**BEFORE THE CANTERBURY REGIONAL COUNCIL
HEARING COMMISSIONERS**

IN THE MATTER	of the Environment Canterbury (Transitional Governance Arrangements) Act 2016
AND	
IN THE MATTER	of submissions on Proposed Plan Change 7 to the Land and Water Regional Plan and Proposed Plan Change 2 to the Waimakariri River Regional Plan

**REBUTTAL EVIDENCE OF MICHAEL JAMES THORLEY FOR THE CHRISTCHURCH
CITY COUNCIL**

Dated 18 September 2020

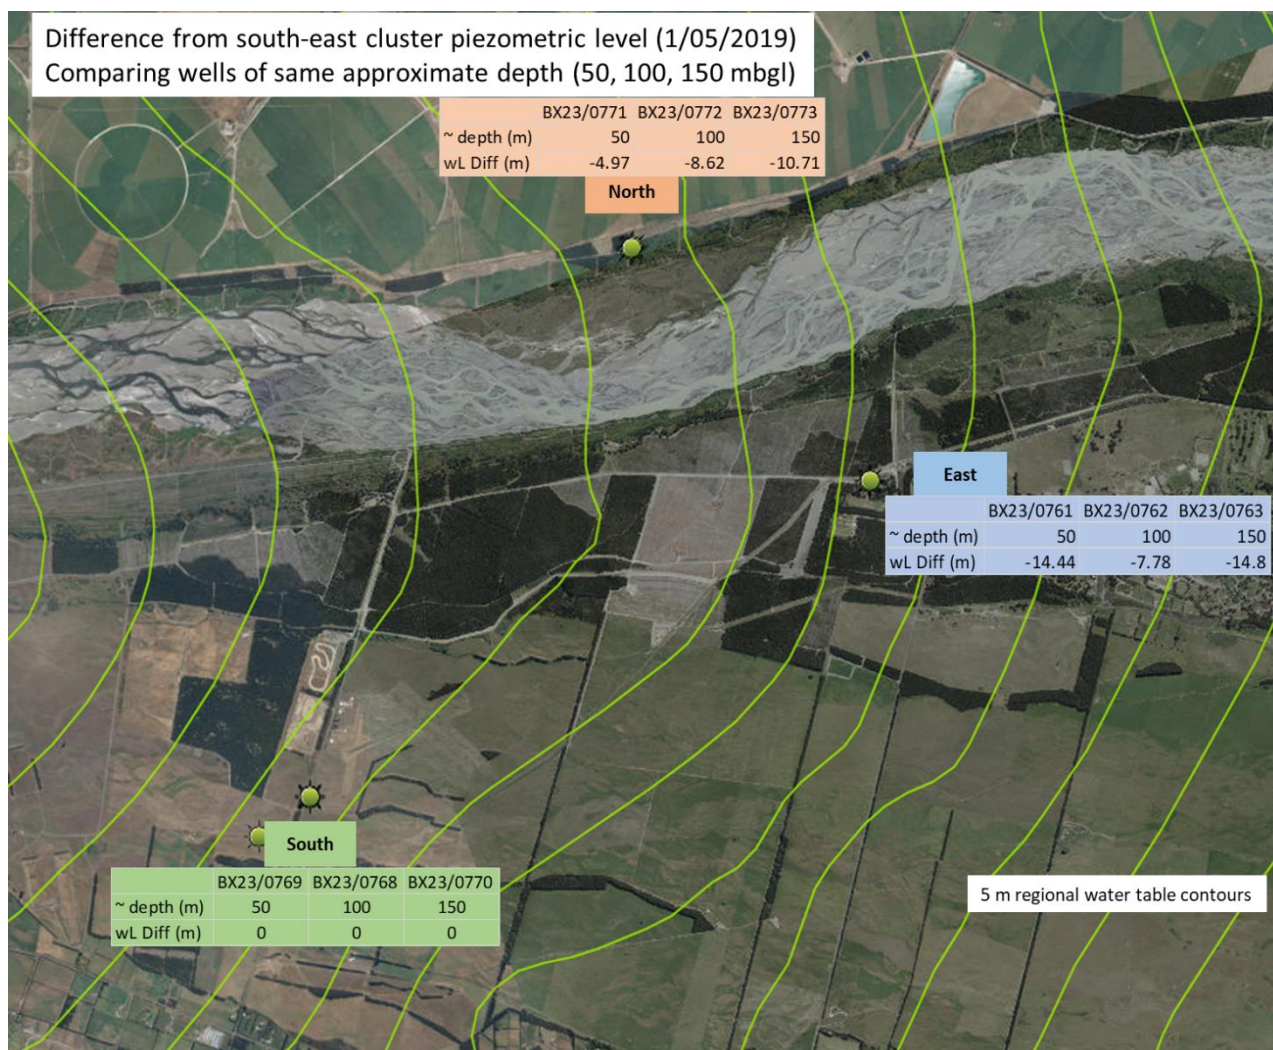
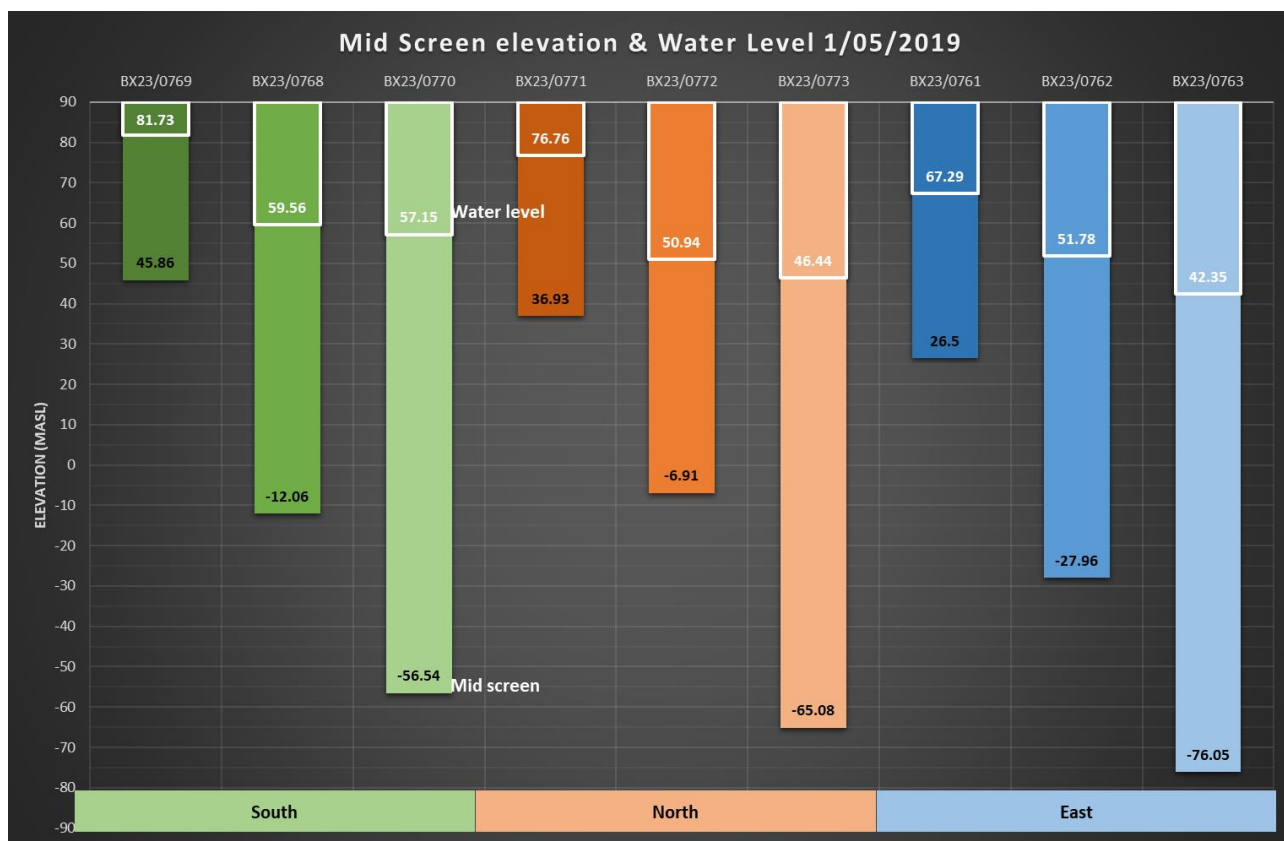
18. In paragraph 50, Mr Thomas describes inferred flow directions from three monitoring bores (BX23/770, BX23/773 and BX23/763) as being approximately parallel to the Waimakariri River. I do not agree with this analysis or interpretation. The analysis oversimplifies the data and does not account for a range of other factors such as differences in bore elevations and wider patterns of piezometric heads. Bore BX23/770 is located 4.5 km across and up-slope of bores BX23/773 and BX23/763. The screen of Bore BX23/770 also sits at a higher elevation than bores BX23/773 and BX23/763, which means bore BX23/770 could be measuring water levels in overlying strata and these could be higher due to the downwards flow pattern in the area. Similarly, there is an approximate difference in piezometric head (groundwater pressure elevation) of 4 – 5 m from bore BX23/773 to BX23/763 towards the south across the Waimakariri River, however the bore screen in the eastern bore is at a slightly lower elevation. Environment Canterbury has provided groundwater level and screen information about the clusters of bores at the three sites which are mapped in Figure 1 and plotted in terms of relative elevation in Figure 2 below.

19. As noted in paragraph 15 of the JWS, the Environment Canterbury groundwater model replicates the relative piezometric head difference albeit with misfit between the measured and modelled levels. On page 15, 3rd paragraph, Etheridge, Hanson and Harris (2018) state *"The experts generally had medium/high confidence that our suite of model results encapsulate the true outcome in regard to impacts on nitrate concentrations in Christchurch. **The results from all models show some increase in nitrate concentrations in Christchurch wells**; it was therefore inferred that the experts had medium-high confidence that there will be some increase in nitrate concentrations due to inter-zone transfer."* [emphasis added]. This statement confirms that all the Environment Canterbury model (2131) realisations, flow and nitrate transport was towards the south across the Waimakariri River.

20. I note that the aquifer system has at least another 100 m of aquifer thickness beneath the monitoring bores (BX23/773, BX23/763, and BX23/770) which is roughly double the depth of those bores and there is significant additional thickness in the aquifer system in which groundwater flow can continue downwards and southwards towards Christchurch. I do not agree with Mr Thomas's interpretation of the groundwater flow

directions based on such a limited dataset, ignoring the downward flow pattern in the area, excluding other pertinent piezometric data across the wider area and the presence of deeper strata below.

21. Based on my review of Mr Thomas's interpretation of the piezometric data and the information provided by Environment Canterbury, I consider there is evidence to support groundwater flow towards the south-east from the Waimakariri Plains to the Christchurch Aquifer System.

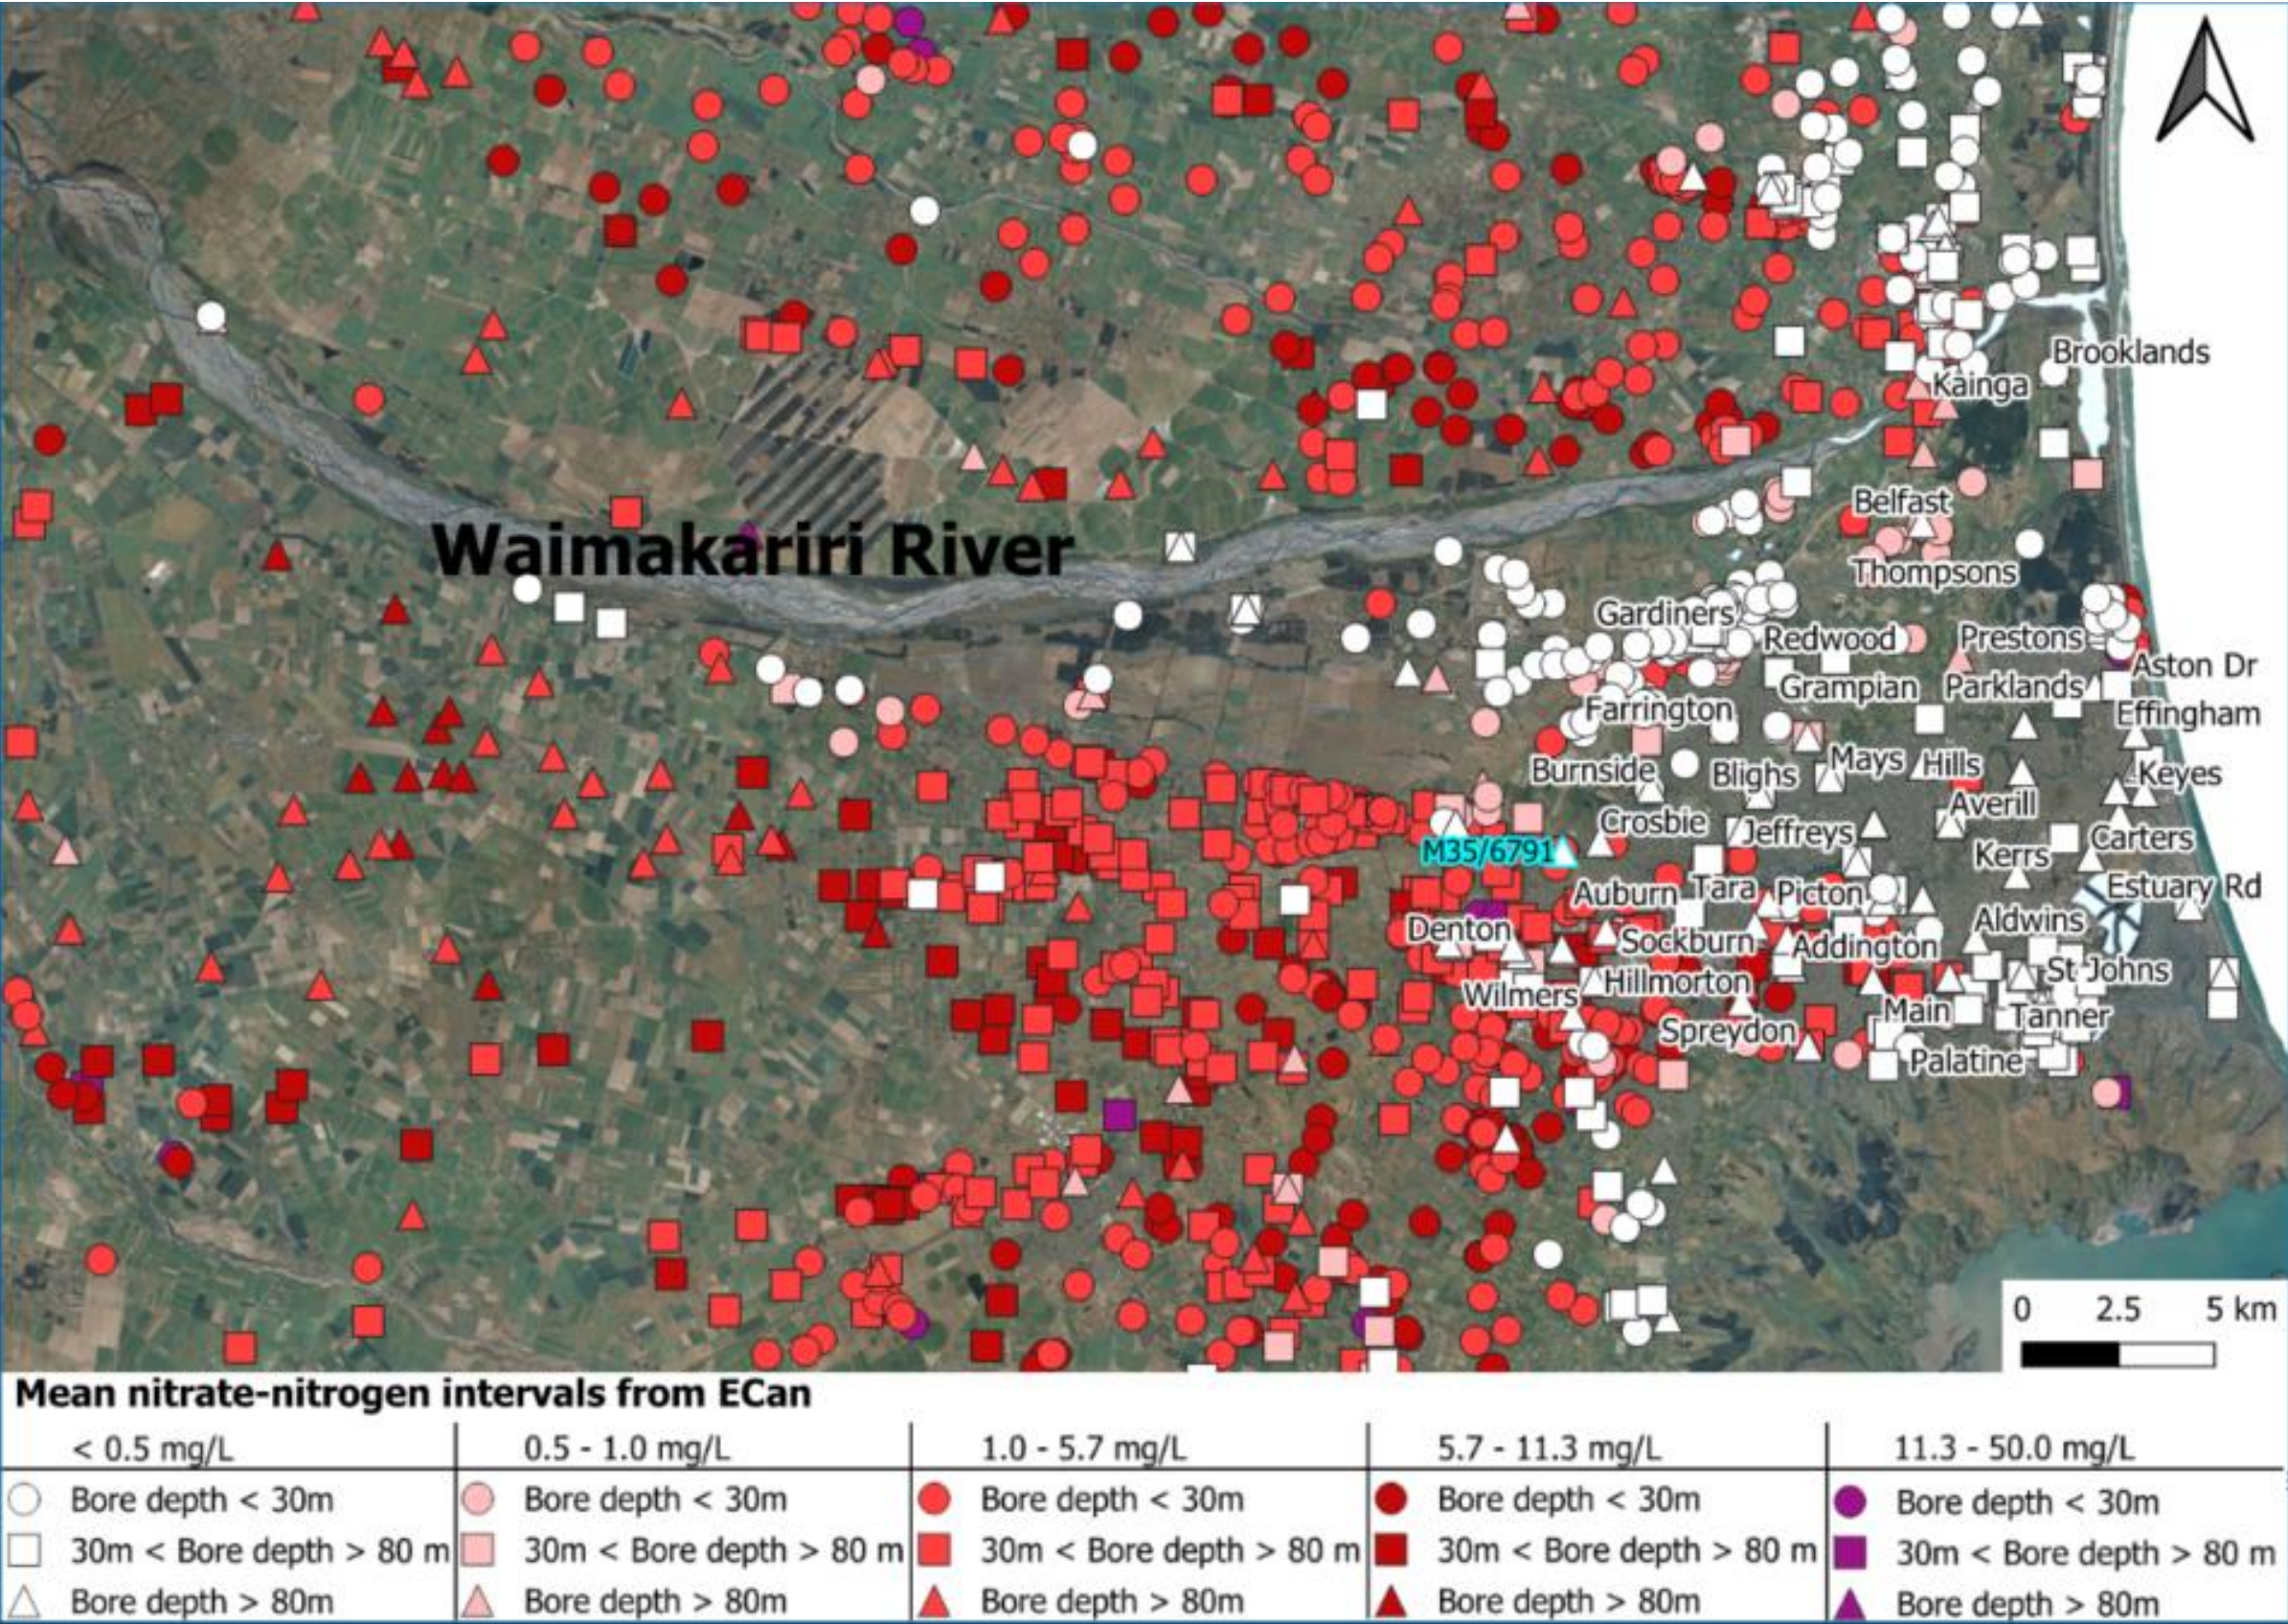
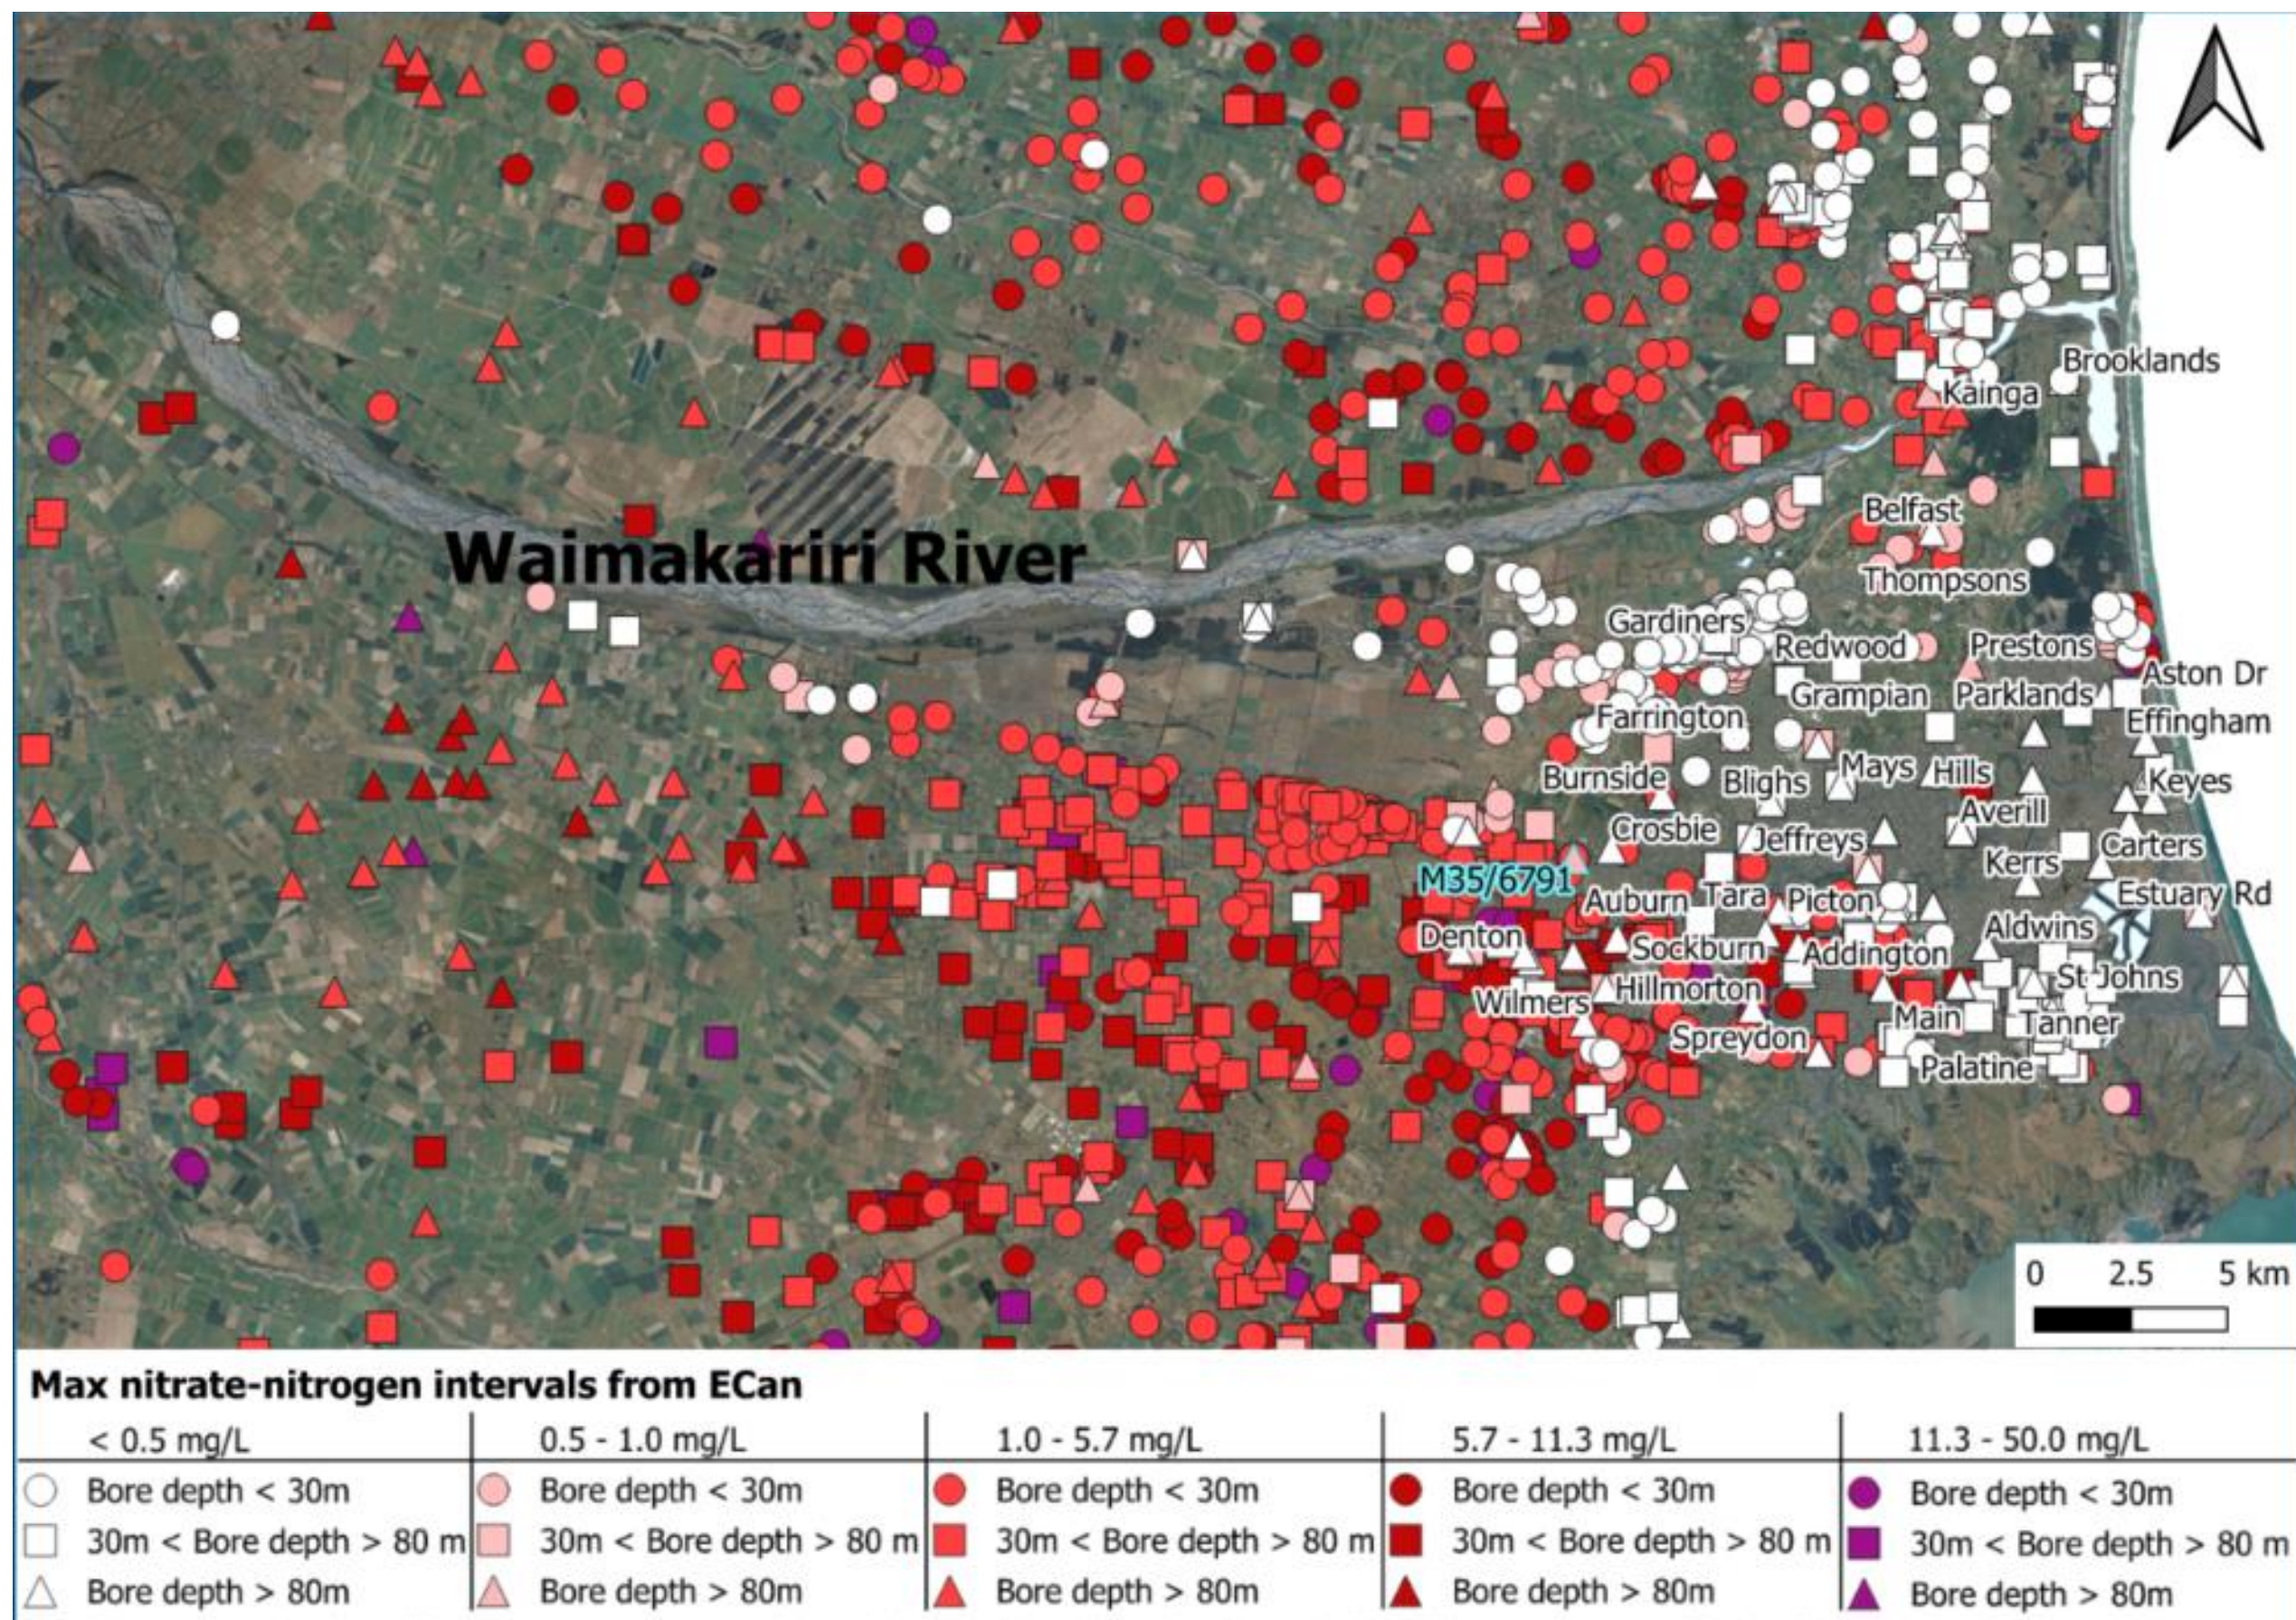
Figures A1 and A2 in Attachment A to this evidence show the position of the Russley monitoring bore M35/6791 and indicate higher average nitrates and historical maxima in nearby bores in both shallow and deeper strata, not just shallow strata as Mr Thomas suggests. Whilst I agree, in part, with Mr Thomas that the spikes in nitrate concentrations could be somewhat explained by vertical leakage, it is also plausible that groundwater containing elevated nitrate concentrations could be drawn through laterally from surrounding areas too. When a bore is pumped, the zone of drawdown influence can extend several kilometres depending on the rate and duration of pumping, and can reasonably be expected to intercept groundwater containing elevated nitrate concentrations as it migrates through the aquifer system from further up-plain.

12. Figures A1 and A2 in Attachment A to my rebuttal evidence indicate widespread elevated nitrate concentrations in many bores across the plains (in shallow and deeper bores) including across western and northern areas of Christchurch. The influence of river recharge is also apparent in nitrate concentrations in groundwater with marked spatial changes in concentrations in the north-west of Christchurch, such as across the West-Melton area.
